SERVICE BULLETIN

PRODUCT: Computer Monitor
BULLETIN: Monitor 95-003
MODEL: CMG7377L

SUBJECT: CRT Substitution

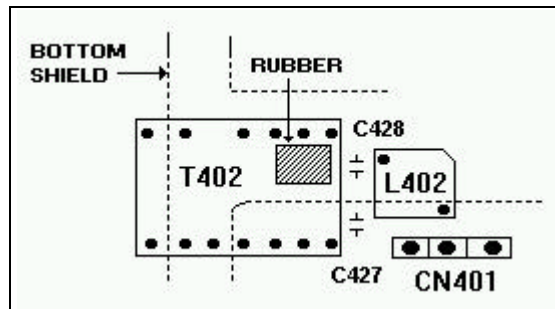
SUBJECT: To prevent whistling sound from occurring.

BACKGROUND: A whistling sound is created from harmonic noise generated between T402, L402, and the main PCB near the Flyback Transformer.

SOLUTION: Add a piece of rubber to insulate the main PCB solder side from the bottom metal shield. See Illustration below showing the section of the PCB where the rubber will be located.

Figure 1

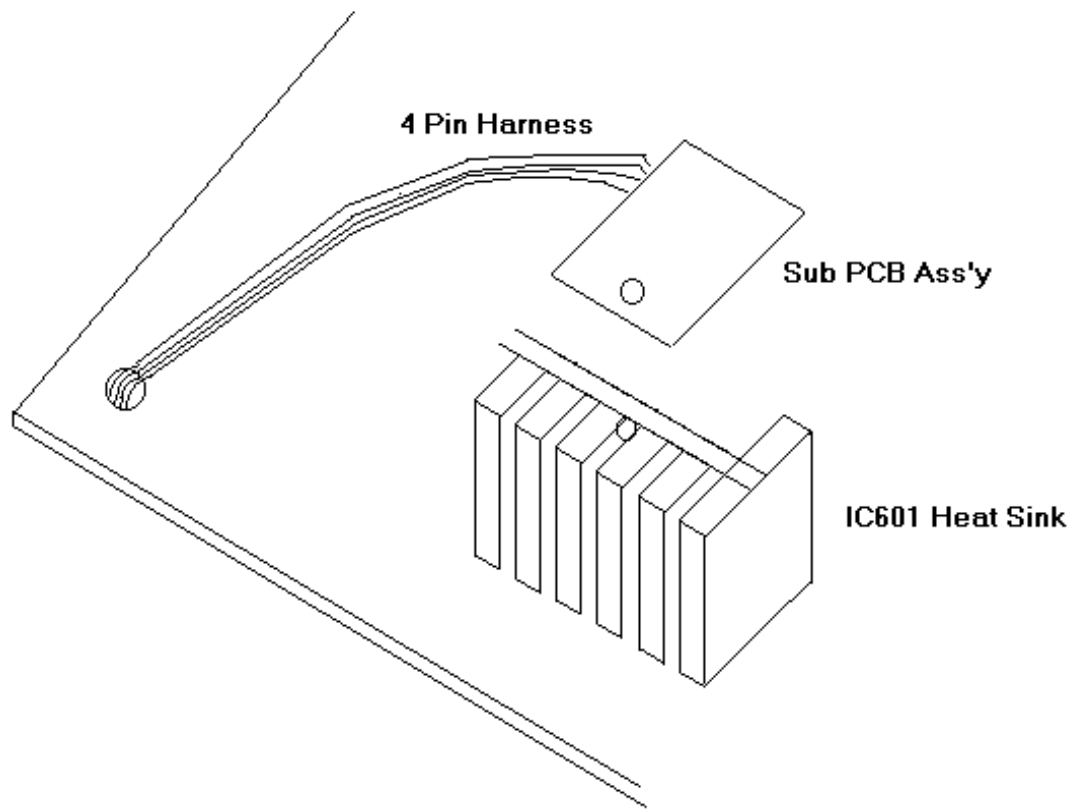
SUBJECT: Q407 Failure Causing No Raster or Small Horizontal Size

BACKGROUND: Q407 fails due to a transient pulse and current when mode switching from DOS to Windows. This occurs with a Matrox video card installed in the computer.

SOLUTION: Add a sub-PCB assembly as in figures 1 and 2 and a snubbing circuit for the horizontal output as in figure 3.
